Bulletin No: Seatback09
Release Date: 5/01/2009
Effective Date: 5/01/2009
Supersedes: N/A
Completion Date: 5/01/2009
Page: 1 of 1

SAFETY ALERT

Ride Manufacturer: J&J Amusements, Inc	Affected production dates: All
Ride Name: J&J Go Karts	Affected Serial Numbers: All
Model Number: All accept Viper, Scorpion & Sidewinder	
Abstract Of Issue: Under severe impact the steel seat back portion of the go-kart frame can become bent forward. This can cause an excess gap between the seat and the roll bar.	
Reason For Release: This gap can constitute a hazard	
Action To Be Taken: If the steel seat back has been damaged contact J&J parts department for an update parts kit. This kit will be provided and shipped to you free of charge. Please advise how many kits (1 per go-kart) are needed. Seatback Reinforcement kit (#1-99-A0003)

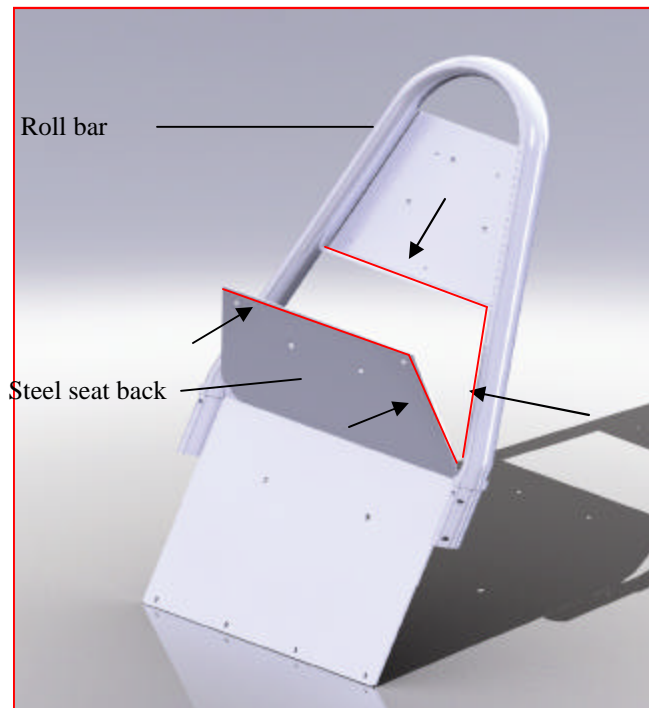
This illustration shows an extreme gap between the seat back and roll bar and would be a hazard.
